Your ref
APP/20/00316

Proposal: Change of use Class A3 (restaurant) to Class A1 (foodstore) with single storey side extensions and alteration to access.

Site: APP/20/00316: - Imperial Palace, 37 Belmont Grove, Havant, PO9 3PT.

Southern Water MapGuide Browser

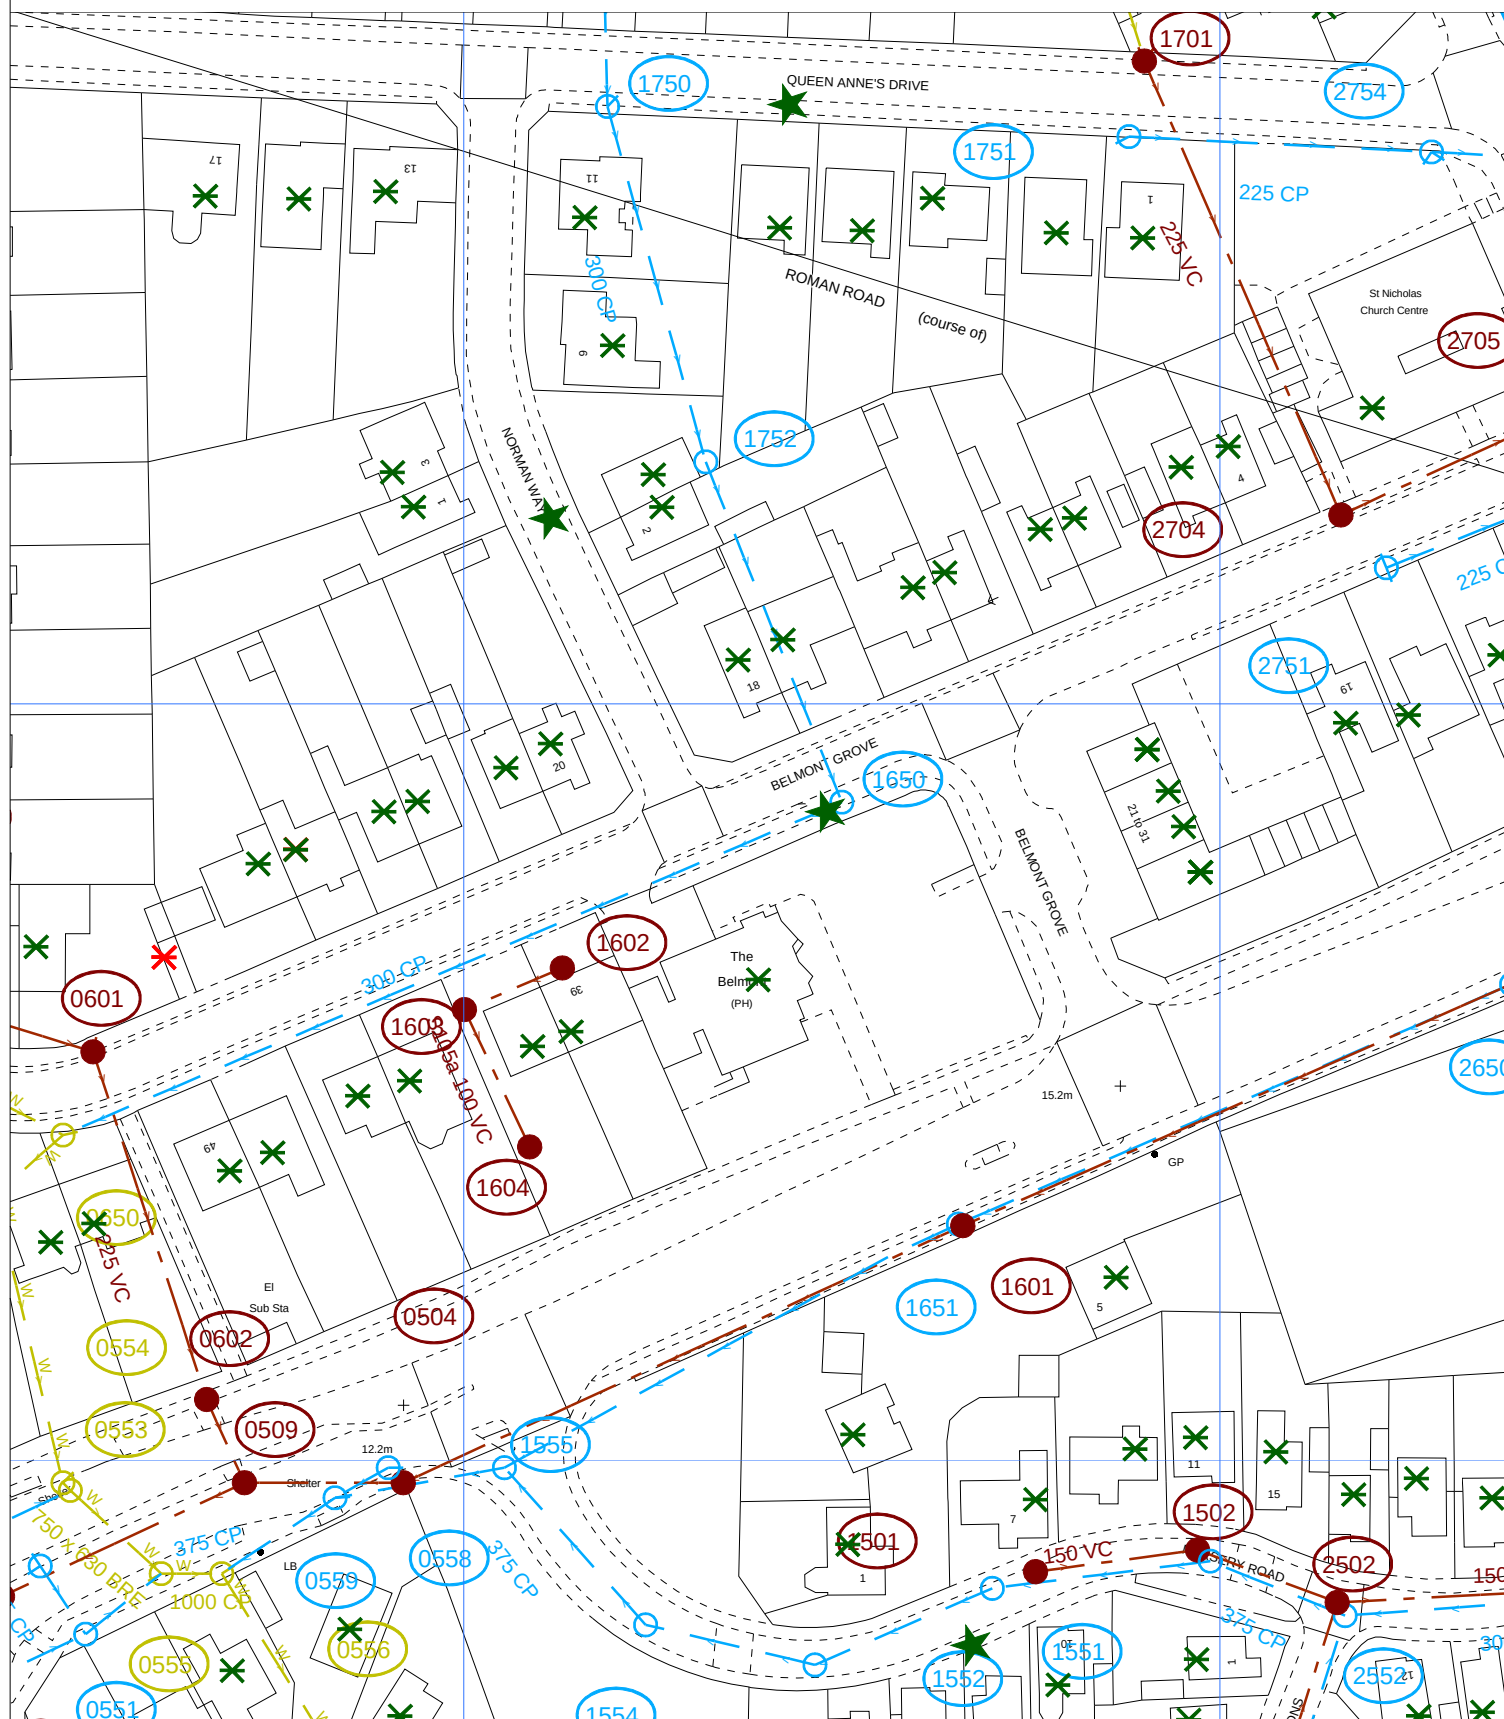
It is possible that a sewer now deemed to be public could be crossing the development site. Therefore, should any sewer be found during construction works, an investigation of the sewer will be required to ascertain its ownership before any further works commence on site.
